2004.07.30 Hw
minor
mod

Re: Minor Modification for re-configuring piping
EPA I.D. No: NYD002014595
DEC Part 373/Air Permit No.3-3340-00027/4-0
Cohoes (C), Albany County

Re: Norlite Corporation
6 NYCRR Part 373 Permit No. 4-0103-16/16-0
6 NYCRR Part 373 Minor Permit Modification-reconfigure piping
for permitted hazardous waste tanks

The following modifications involve changes to the piping of the permitted hazardous waste storage tanks 335-300, 400, 500 & 600 (outside tanks). The revised drawings reflect the following changes:

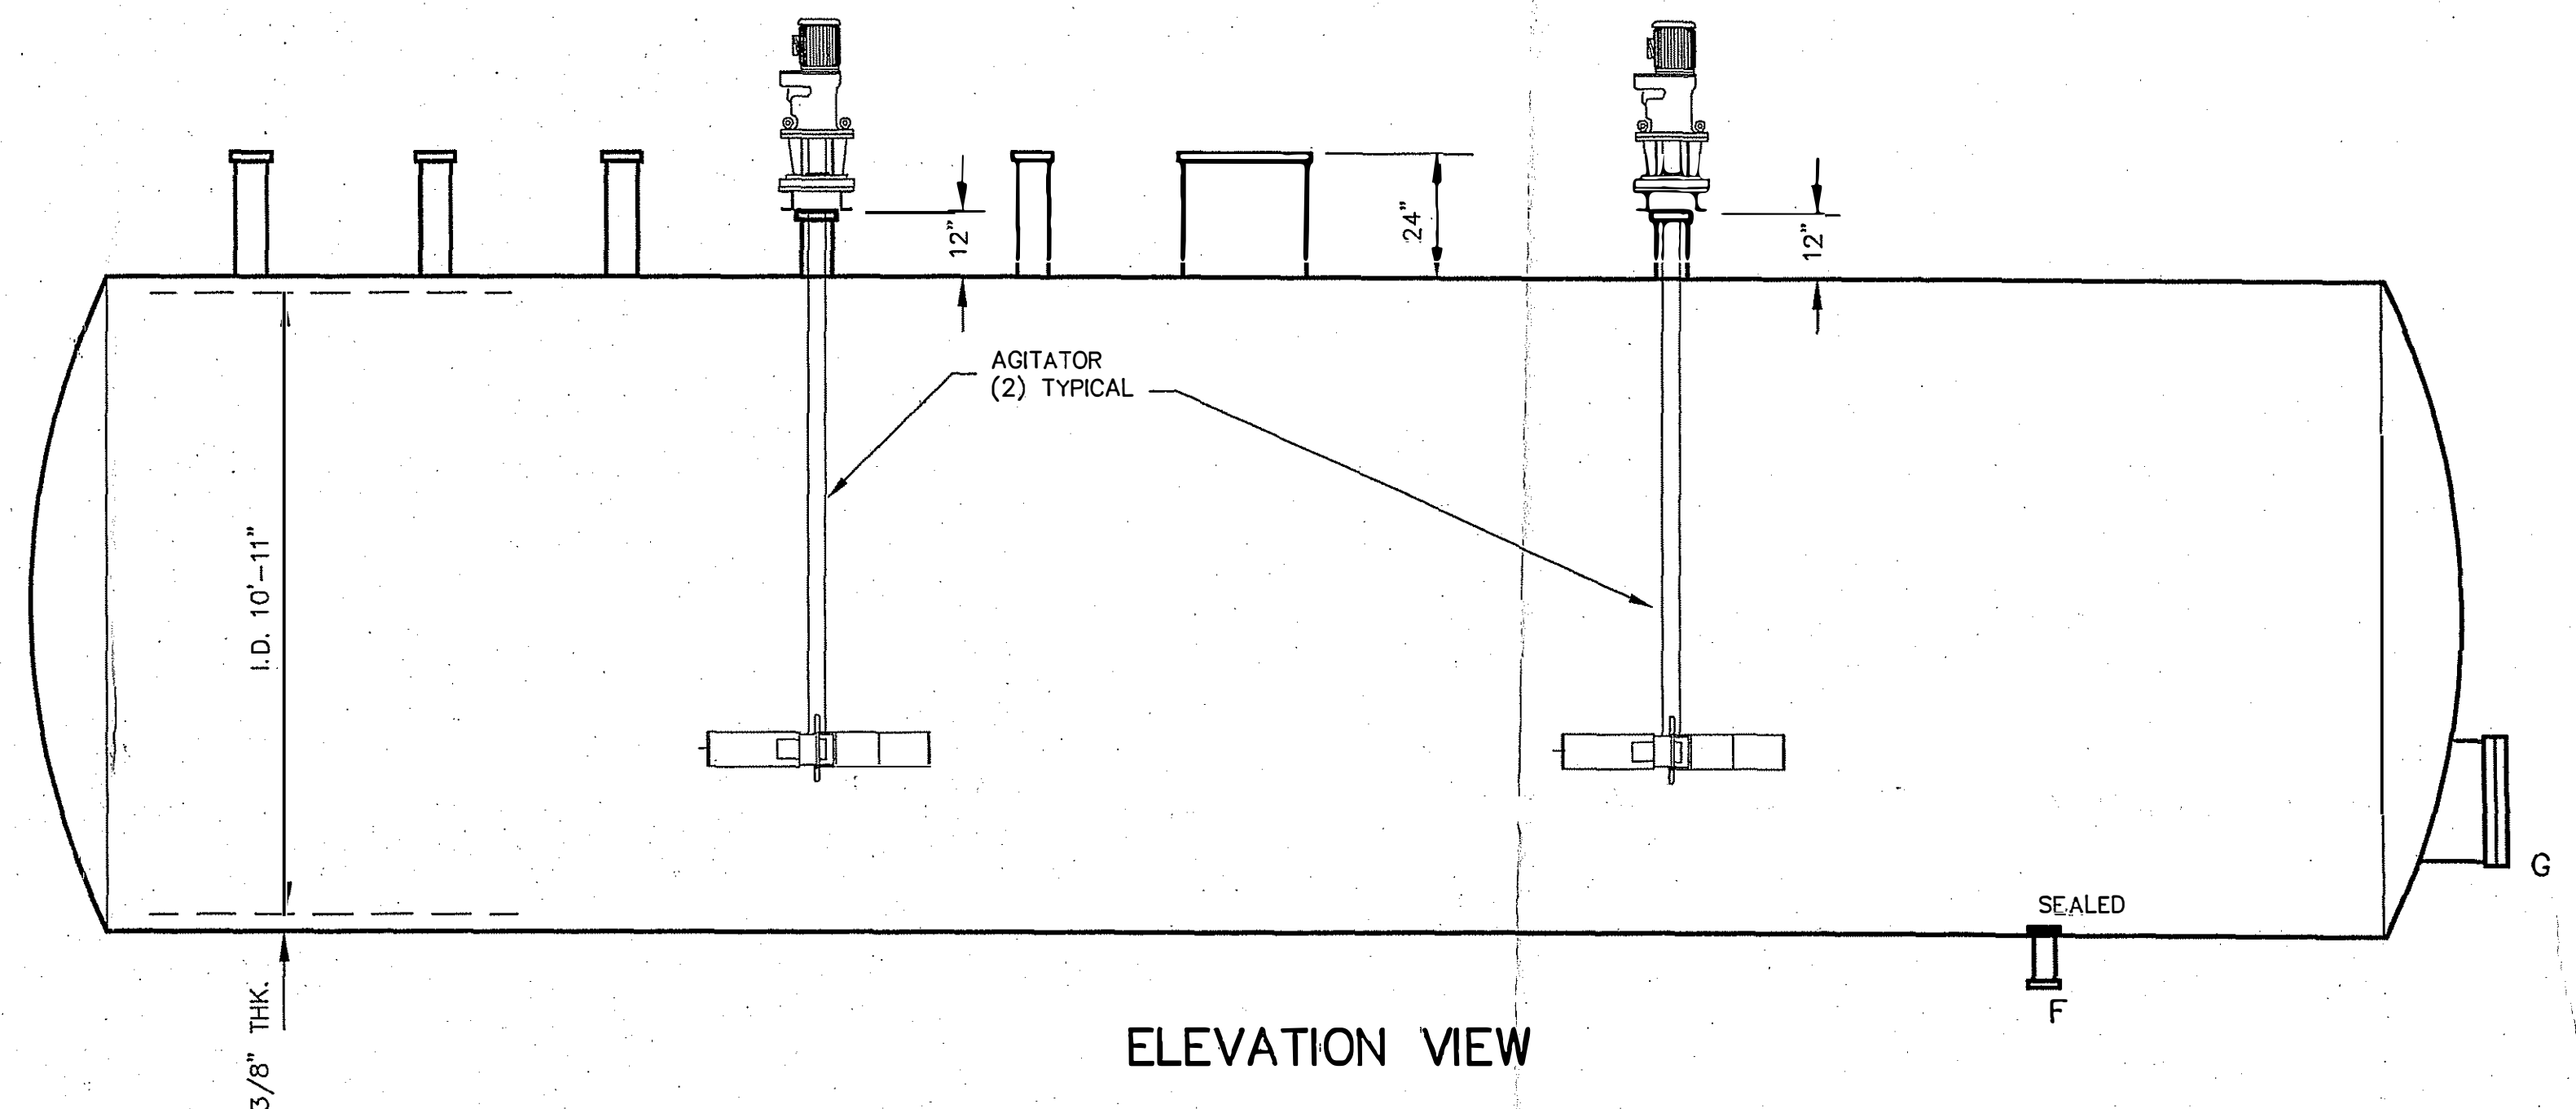
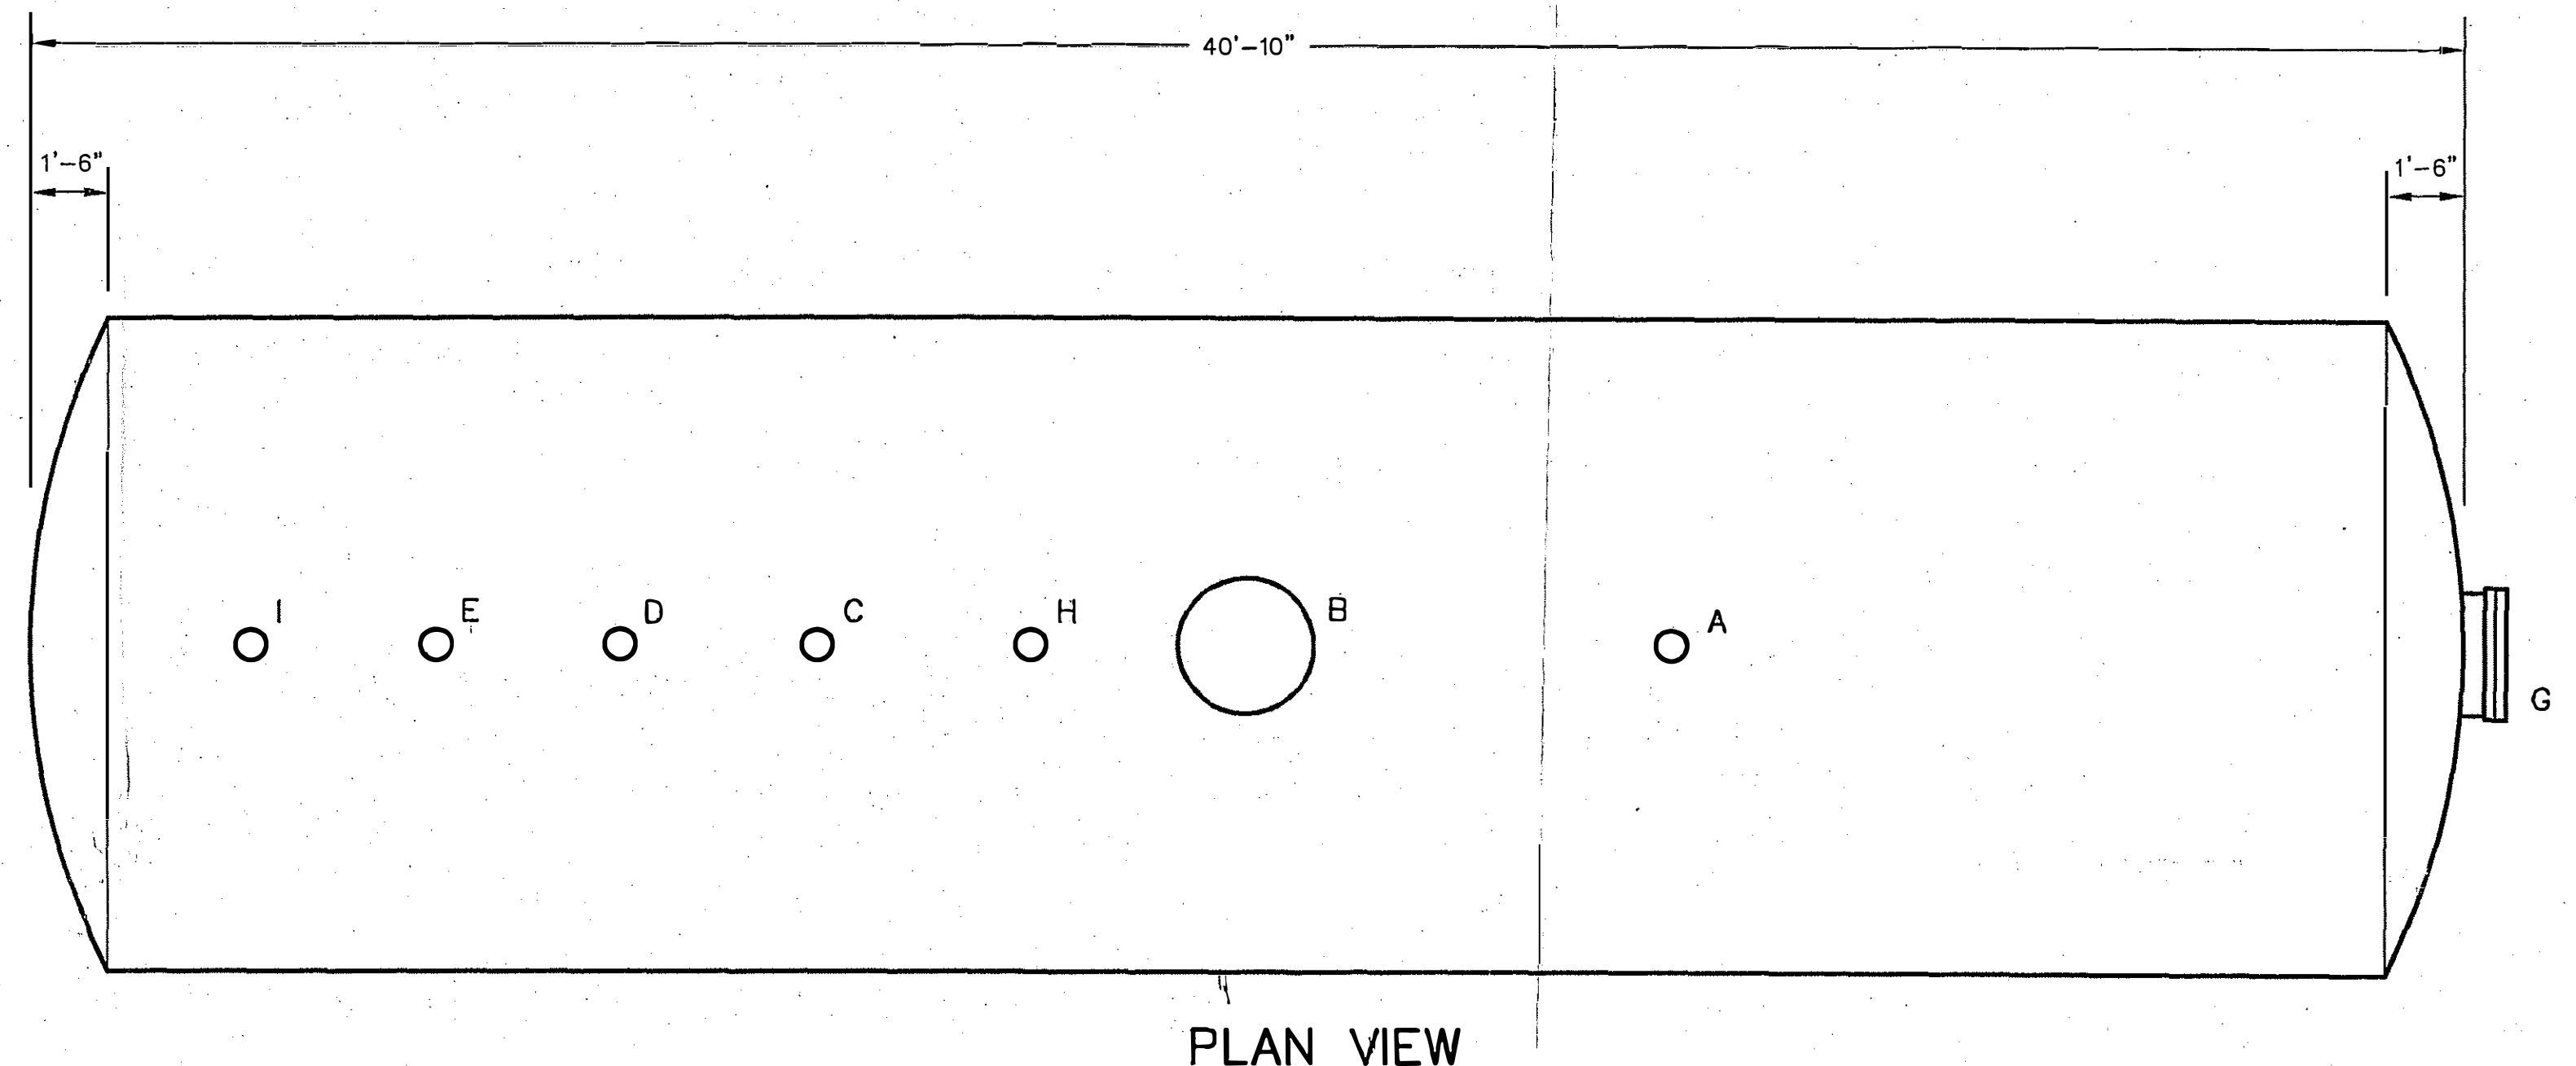
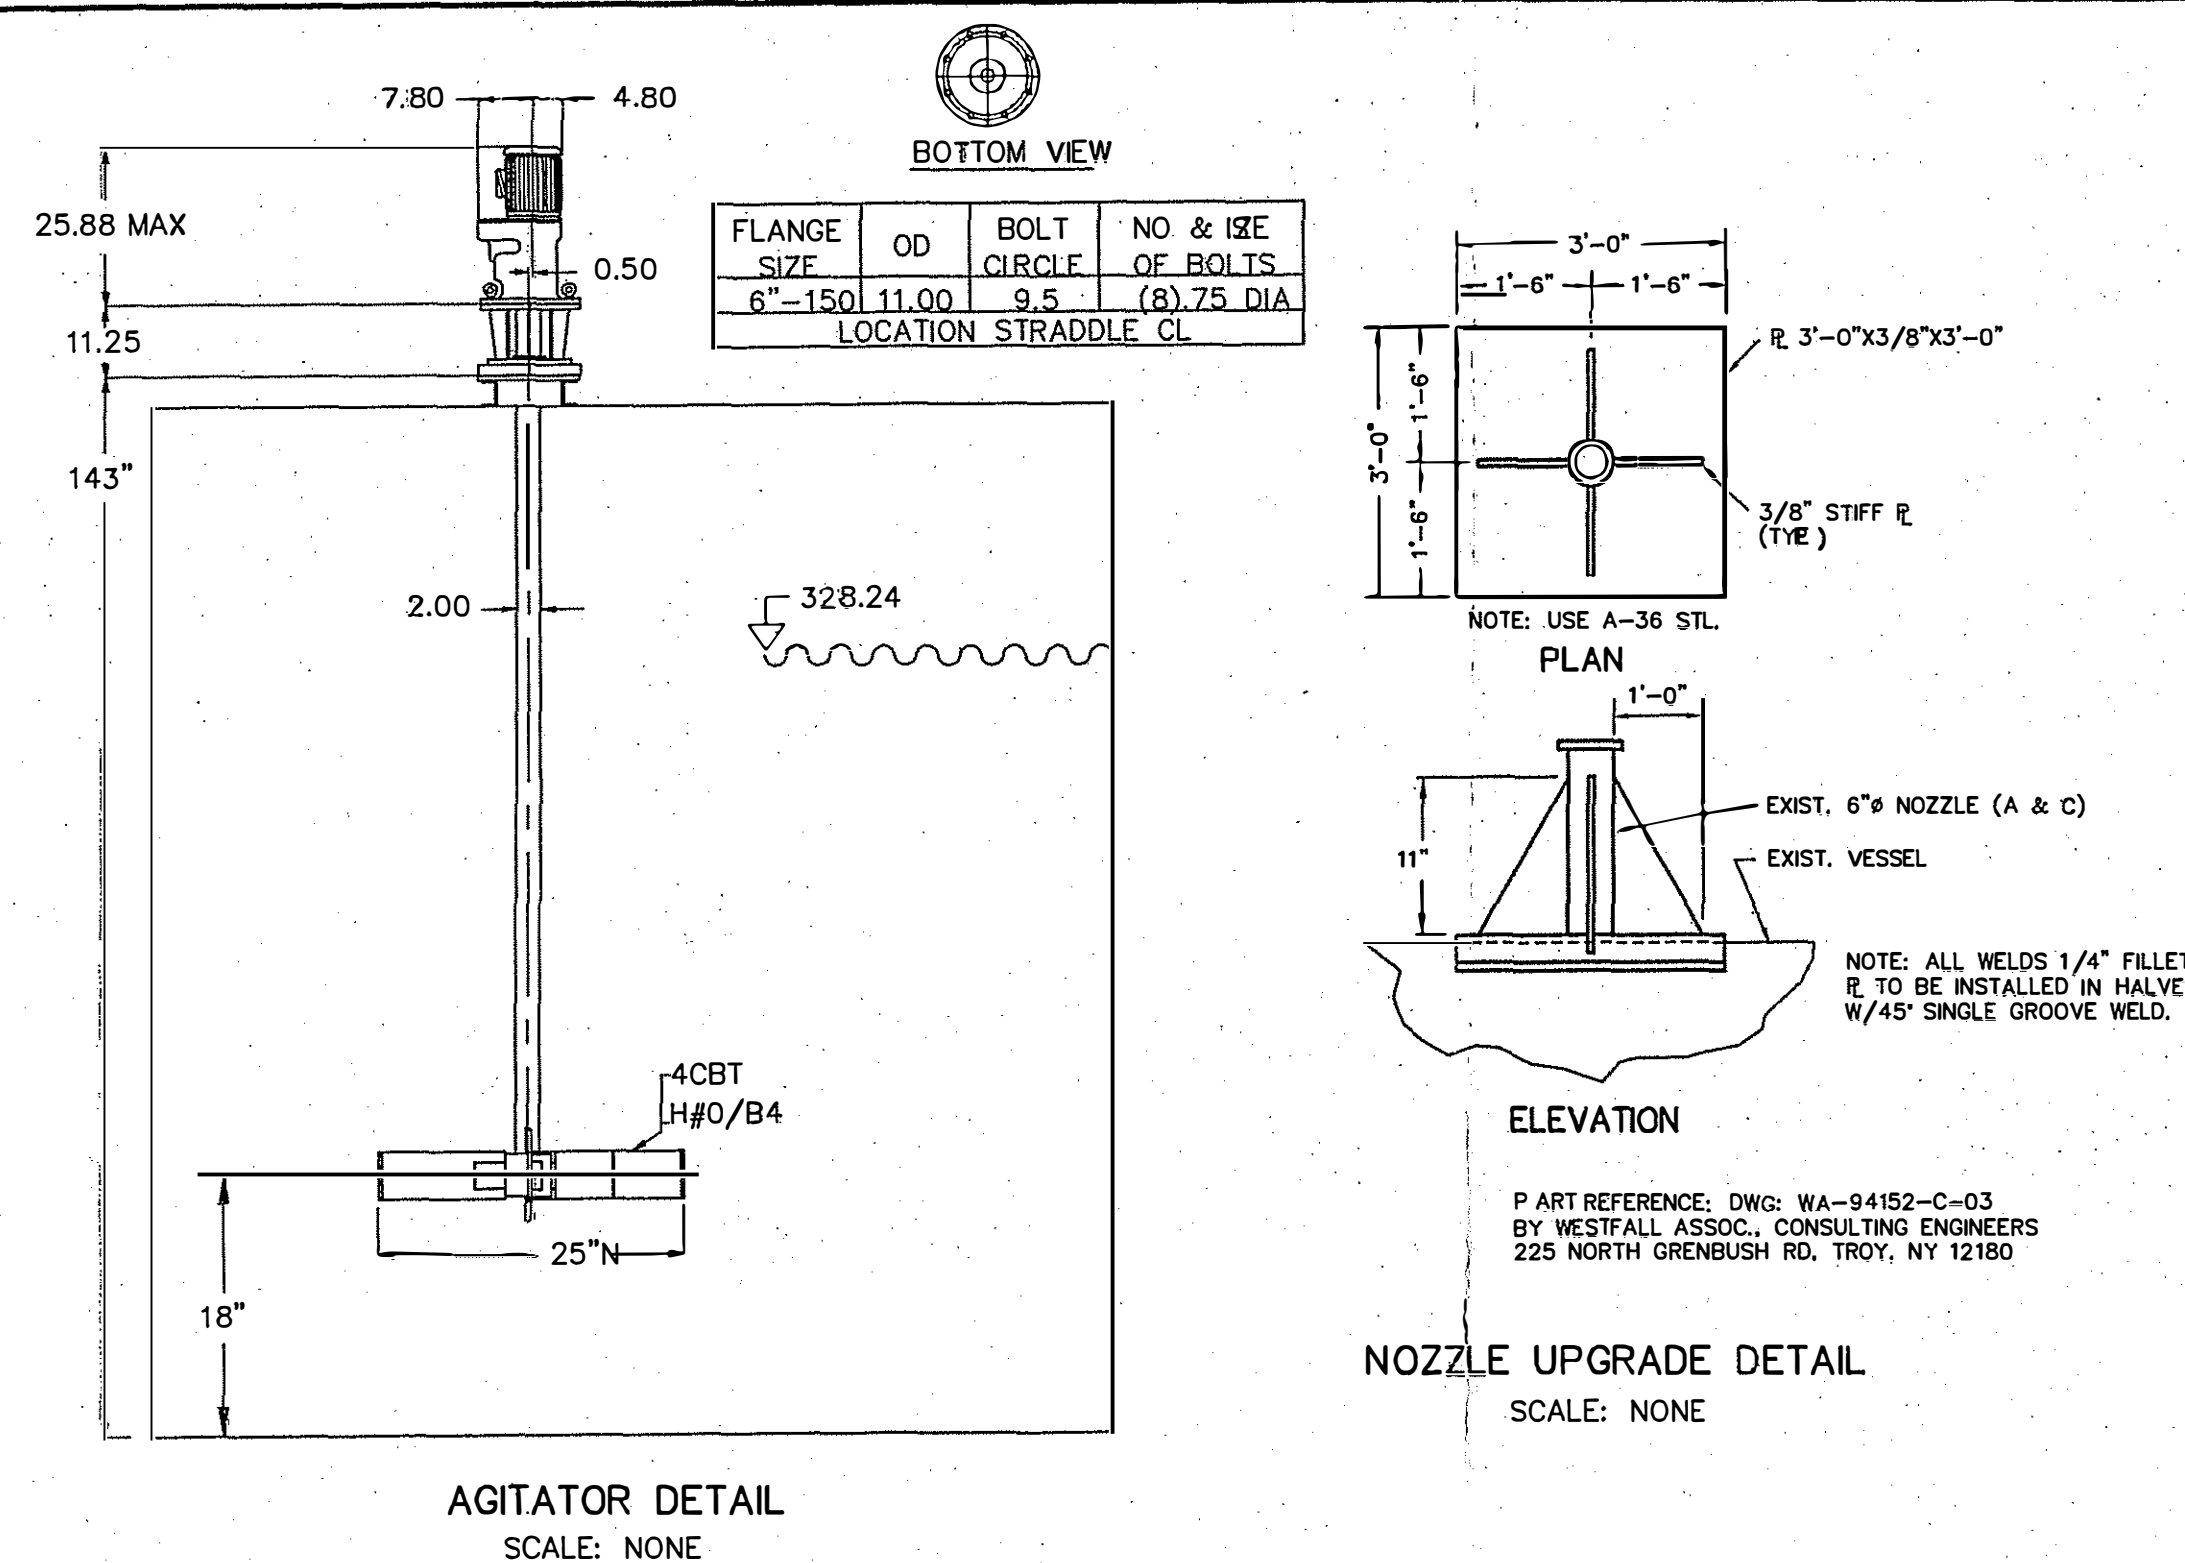
- The installation of new piping, valves and tank nozzles will allow Norlite to unload directly from Unloading Area #2 to the outside tanks. These modifications are shown on drawings: NY003-1317, NY003-5432, NY003-5433 and NY003-5434.

- The installation of new piping, valves and tank nozzles, as well as modifications of existing piping, will facilitate the recirculation of LGF from the kiln burners back to the outside tanks. The recirculation will only occur after the agitators have been installed as per the modification approved on April 20, 2004. These modifications are shown on drawings: NY003-1312, NY003-1314, NY003-1315, NY003-1317, NY003-5432 and NY003-5433.
